**GOVERNMENT OF THE DISTRICT OF COLUMBIA
DEPARTMENT OF TRANSPORTATION**

MEMORANDUM

SUBJECT: **BZA Case No. 19377 – 3015 4th Street NE (St. Paul the Apostle Townhomes)**

Figure 2 – Public Access Easement Diagram (Source: Vika Capitol, Exhibit 170C)

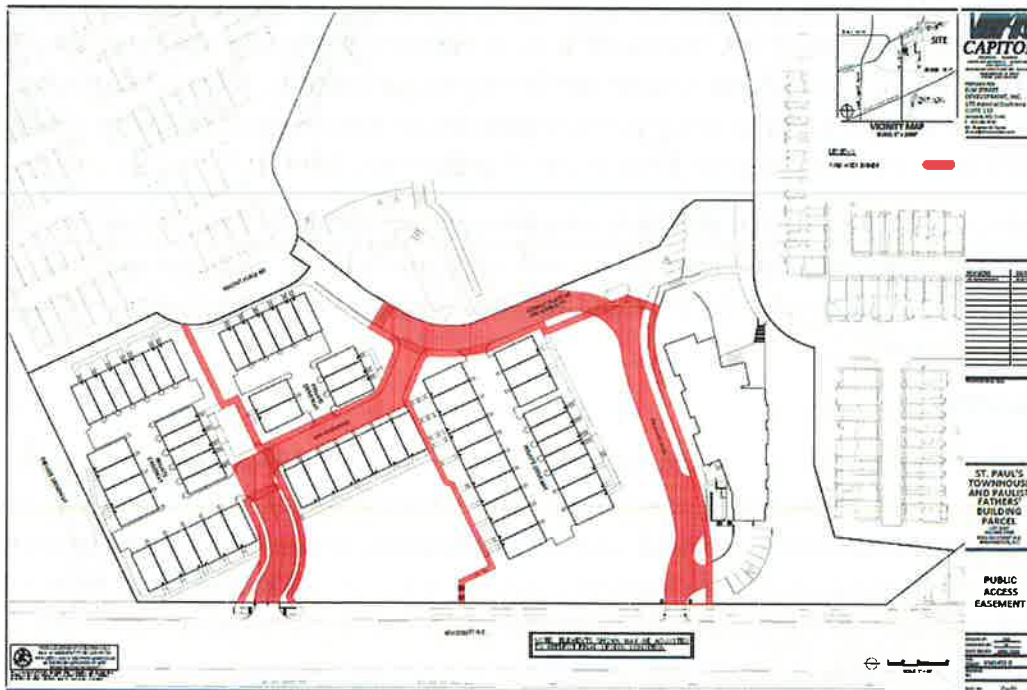
public access easements on the sidewalks and roads proposed for their property, as shown in red in Figure 2. DDOT supports the location and provision of the proposed easements.

Figure 3 – Public Access Easement (Source: DDOT March 9, 2018 Report)

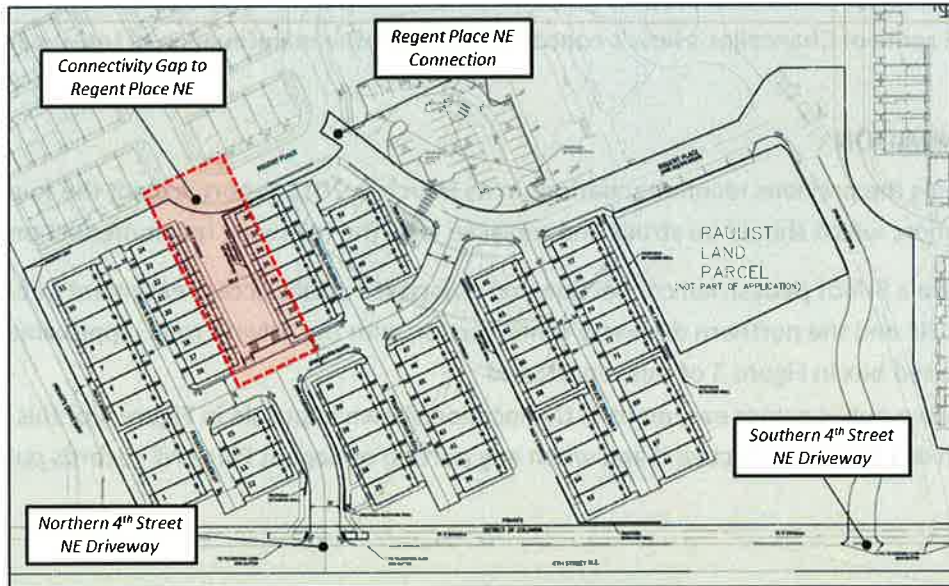
In its March 9, 2018 report, DDOT recommended the Applicant provide a public access easement no less than 42 feet wide, as approximated in Figure 3, to ensure that future road connections not be precluded

between the proposed road network and existing Regent Place NE. The Applicant team coordinated with DDOT to develop a concept in which the public access easement shown in red would become legally effective if and when public access was recorded over any portion of Regent Place NE on the adjacent Chancellor’s Row property. During the April 25, 2018 hearing, this easement was referred to as a “Springing Easement” because its effect was not immediate, and tied to the adjacent property.

After its April 25, 2018 hearing, the Applicant contacted DDOT to coordinate further regarding the “springing easement” concept and its location. Based on concerns from Chancellor’s Row residents, impacts to existing trees and open space, and potential implications related to financing, the Applicant team was no longer comfortable with a public access easement at the location approximated in red in Figure 3 and alternatively offered a “springing easement” in the location shown in purple in Figure 4.

- Provide a 6-foot pedestrian connection and associated public access easement between Regent Place NE and the northern driveway's intersection with the private road, approximately shown in the red box in Figure 3 of this report; and
- Provide a public access easement in the location shown in purple in Figure 4 of this report, which will become effective if and when any portion of Regent Place NE records public access.

Figure 4 – Potential Additional Public Access Easement Diagram (A.K.A. “Springing Easement”) (Source: Vika Capitol, Exhibit 170C)

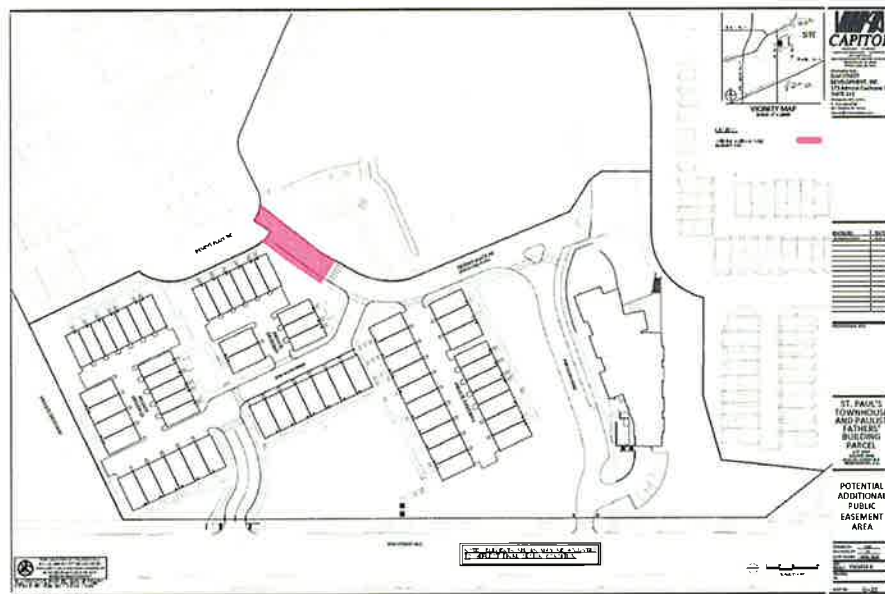
DDOT prefers the initial location because the driveway to the Paulist building is narrow and is designed to look and feel more like a driveway than a street. Additionally, the Applicant's initial plan schemes included a road connection at the former location suggesting such a connection was feasible. Despite this preference, DDOT is willing to accept the alternative location for the "springing public access easement" as a compromise. The proposed location should reduce the Applicant's concerns related to financing and some of Chancellor's Row's concerns related to the maintenance of trees, open space, and traffic.
